APPENDIX G
FIELD WORK VARIANCES

FIELD WORK VARIANCE

PROJECT NAME: Former Conway Bombing and Gunnery Range RI/FS

FWV 003, Alternative Approach for placement of DGM grids

Figure 1
MRS-R02
Proposed Grid Locations

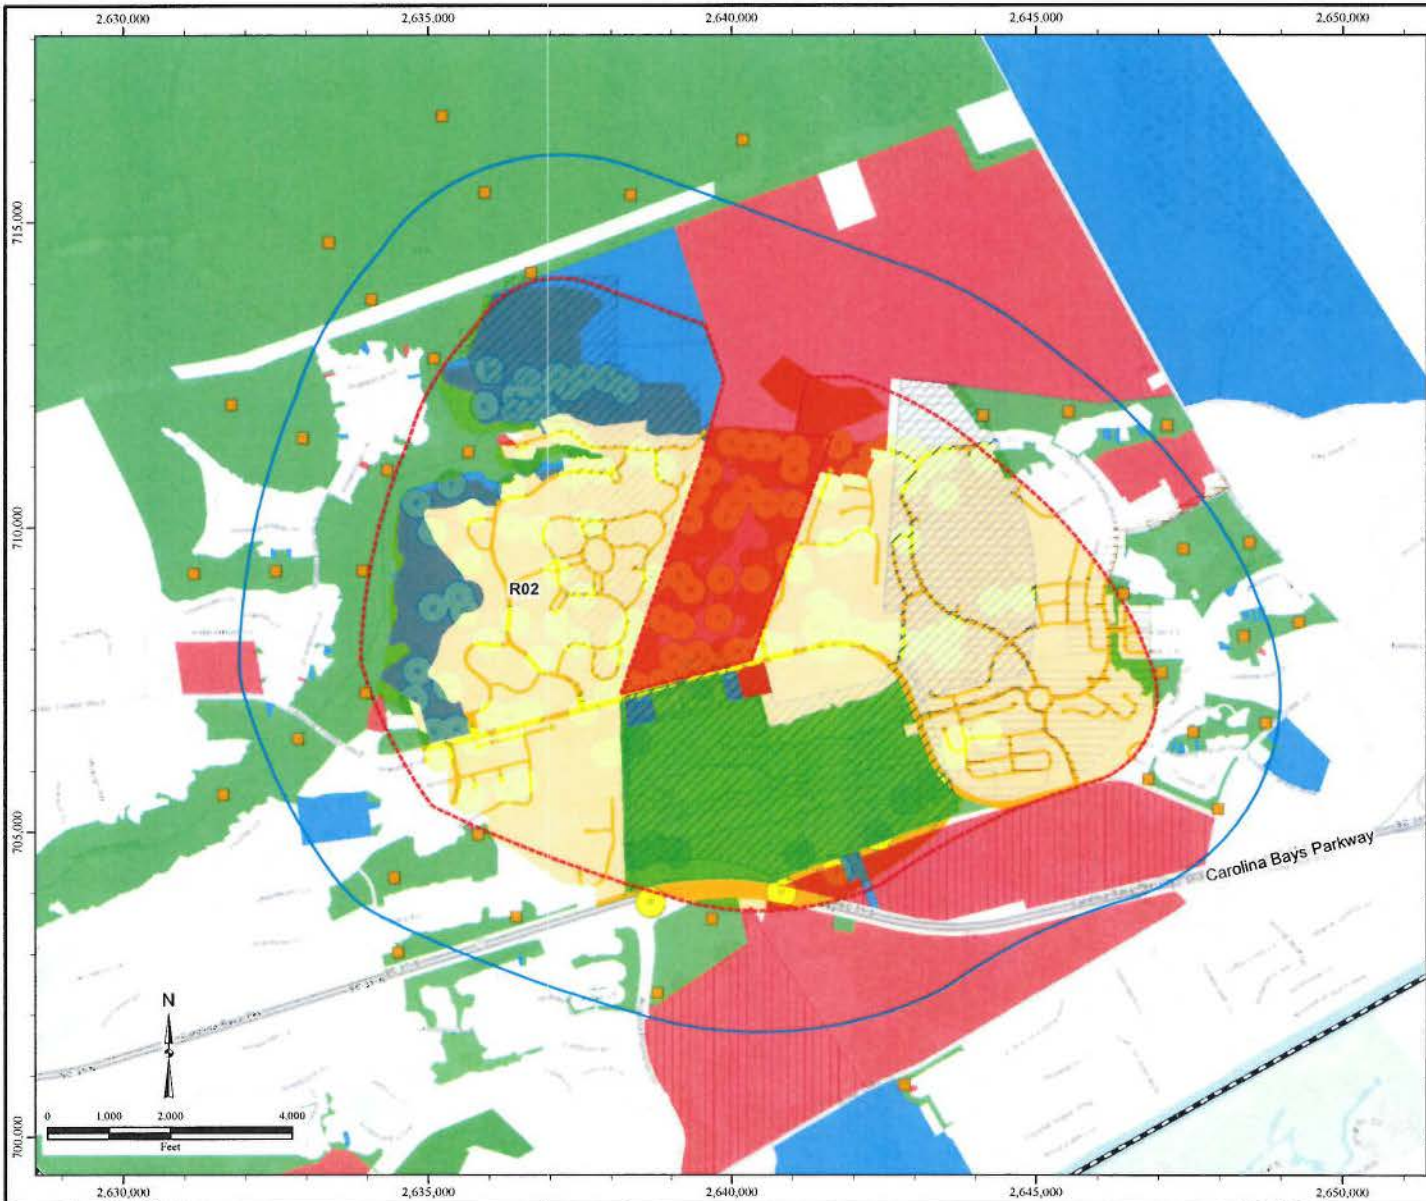
Previous intrusive investigations in MRS-R02 and R03 have identified central target areas in each MRS. Strategically located DGM grids can be used in lieu of transects to define the boundary of the target areas in MRS-R02 and MRS-R03. HGL proposes to place the DGM grid locations by using all available DGM transect data from the current investigation, previous RI/FS investigation data (geophysical survey and intrusive data), and previous removal action intrusive data in order to propose grid locations appropriate to delineate the extent of MEC contamination. Previous investigation efforts at MRS-R02 and MRS-R03 were much more extensive than those performed at MRS-R01. At MRS-R02 and MRS-R03 intrusive activities were performed within the presumed bombing targets and MEC and MD were identified (Figure 1).

The DGM grids and additional intrusive transects will be strategically placed for approval by the client to provide additional characterization information. In general, DGM grids may not require extensive vegetation clearance compared to transects, as relatively less vegetated areas and areas without water deeper than 1.5-ft can be selected, in close proximity to the planned location. The locations of grids appropriate to complete the boundary characterization at MRS-R02 are provided in Figure 1.

Figure 2, MRS-R02, ROE Refusal on the East

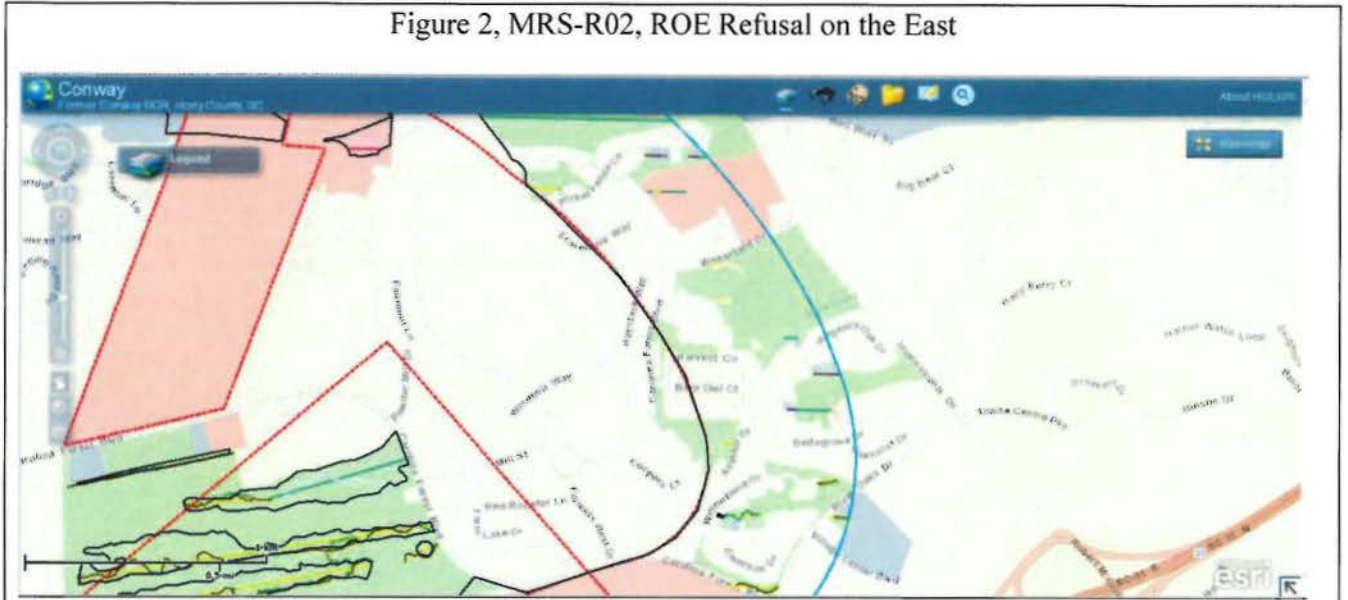
ROE refusal on the eastern side of MRS-R02 has reduced the amount of parallel DGM transect mileage that can be completed (Figure 2, screenshot). ROE refusal and impassable areas of the available parcels on the western side of MRS-R02 has reduced the amount of coverage by parallel transects that can be completed (Figure 3, screenshot). HGL has completed 10.8 miles of

Figure 4, MRS-R03, ROE Refusal to the South

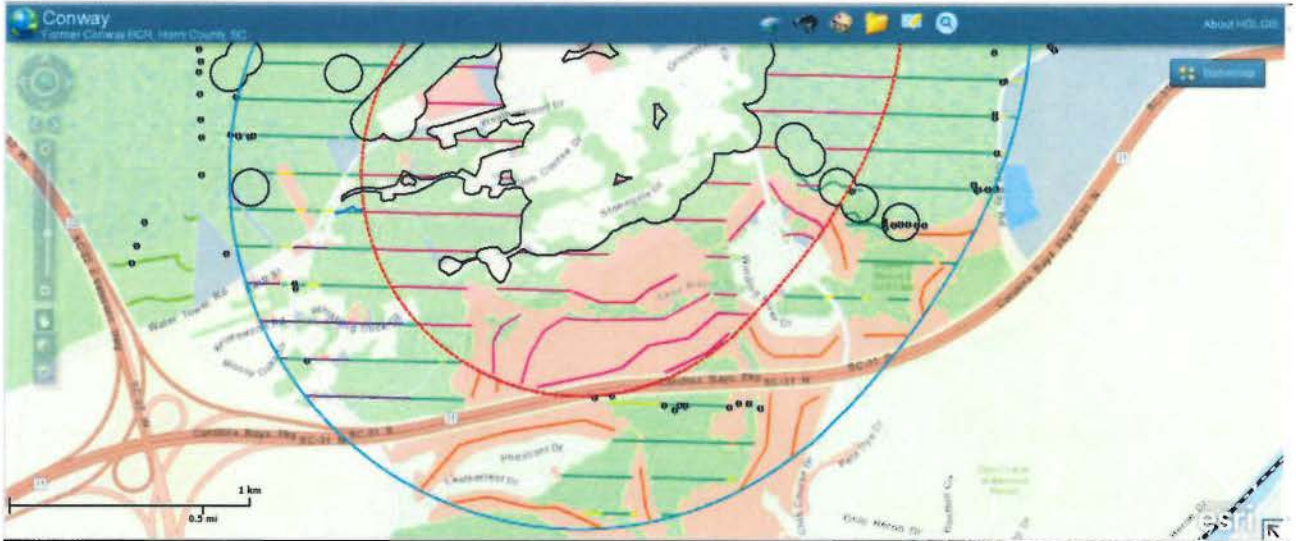
ROE refusal on the southern side of MRS-R03 has reduced the amount of parallel DGM transect mileage that can be completed (Figure 4, screenshot). Inundated areas of the available parcels on the northeastern side of MRS-R03 has also reduced the amount of coverage by parallel transects that can be completed (Figure 5, screenshot). HGL has completed 3.2 miles of vegetation clearance in MRS-R03 of the proposed 11 miles available to be completed based on ROE granted.

Figure 5, MRS-R03 impassable areas to the northeast

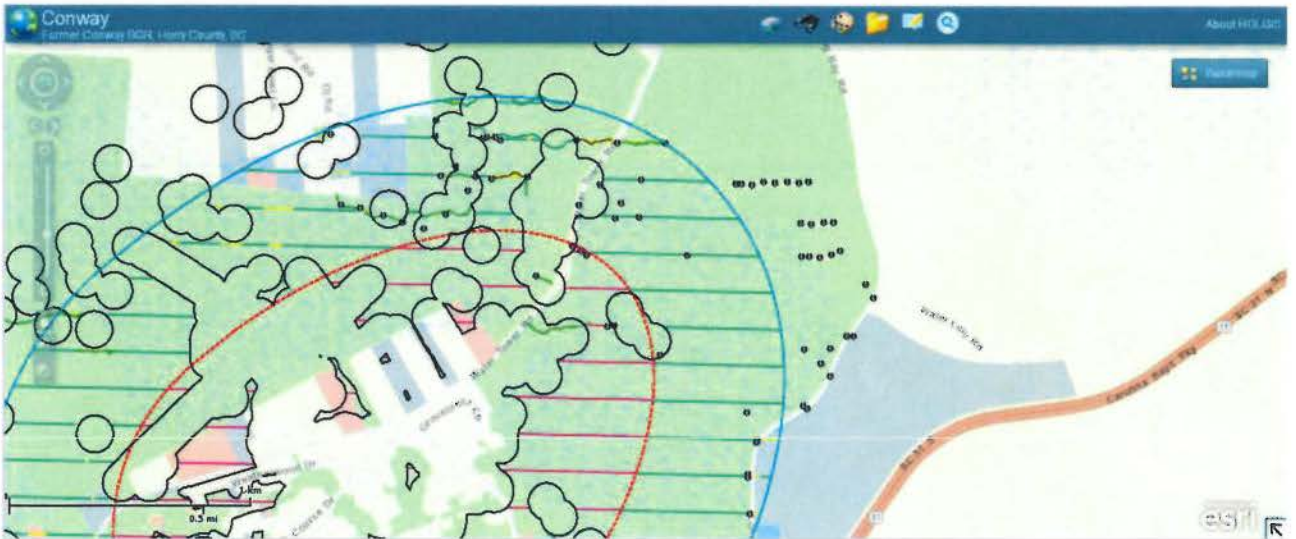
Black observation dots shown along transect lines mark areas which were noted by HGL teams as impassable due to vegetation, flooded areas, streams or ravines, and/or unable to collect DGM data.
